ADDENDUM TO LANDSCAPE AND VISUAL IMPACT ASSESSMENT LAND NORTH OF WATER LANE, ANGMERING, WEST SUSSEX

Prepared for:
RYDON HOMES LTD AND GLEESON LAND

Report Reference: HBA/875/REP/LVIA ADDENDUM

Figure HBA 2: Copy of updated Land Use Parameter Plan (drawing 19271 rev C01) by OSP

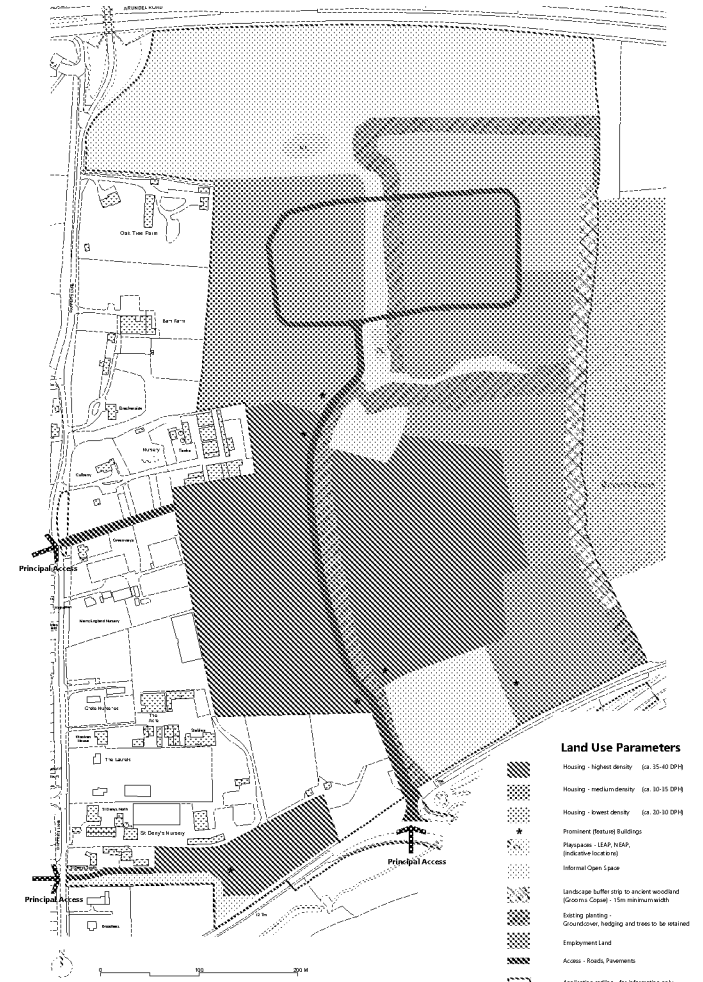
Land Use Parameter Plan

- Reconfiguration of the housing and open space on the northern side of the scheme with lowest density housing extending 20m further north on the north-east side of the site, and lowest and medium density housing extending up to 90m further north on the north-west side of the site.

- The Parameters now propose lowest density housing along the northern edge of development and addressing the retained woodland and ancient woodland buffers.

- Provision of a wider north-south spine of green space through the site which tapers out to the northern open space rather than funnelling into it.
- Removal of bunds (and existing vegetation upon them) from around the Oval Raceway.

- Provision of an increased open space buffer to the existing woodland planting located south of the Oval Raceway and extension of this space east-west across the site to connect to the western site boundary.

- Retention of existing vegetation and trees on western site boundary (to link to increased east-west open space/vegetation).
- Realignment of primary access road to avoid mature trees.

- Provision of informal open space as a focus point along the north-south open space and at the centre of the highest density area.
- Inclusion of 6m buffer to southern site boundary on Parameter Plan.

Figure HBA 5: Copy of updated Building Heights Parameter Plan (drawing 19271 rev P02) by OSP

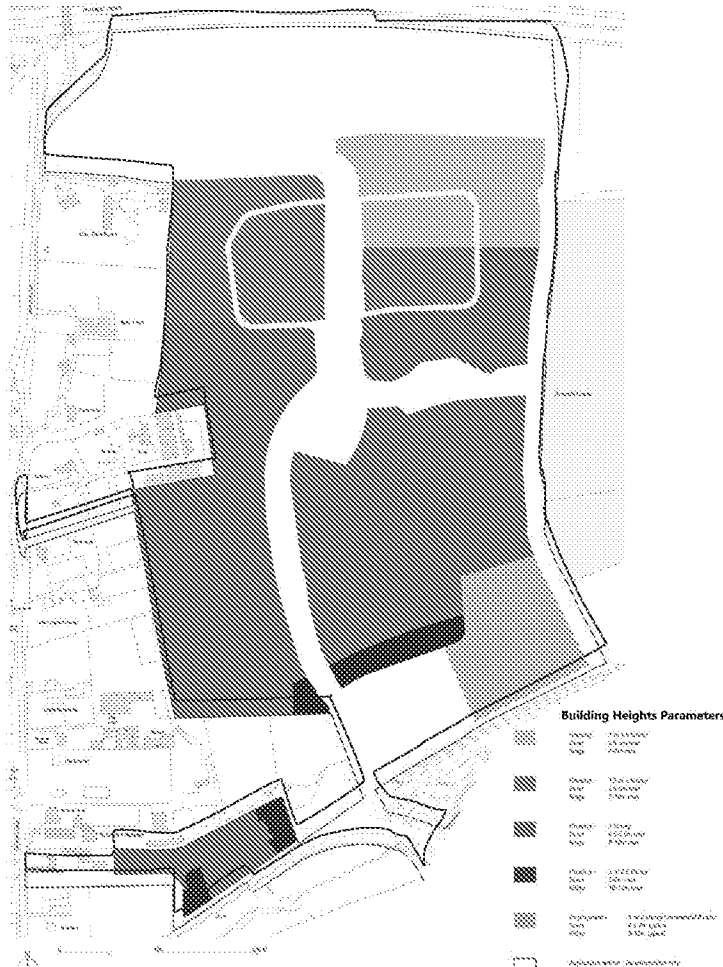
Building Heights Parameter Plan

- Extension of 1 or 1.5 storey housing approximately 20m further north on the north-east side of the site
- Extension of 1 or 1.5 storey and 1.5 or 2 storey housing approximately 90m further north on the north-west side of the site.
- Incorporation of discrete areas of 2 or 2.5 storey housing (10-12m ridge height) in areas of highest density in the southern half of the site.
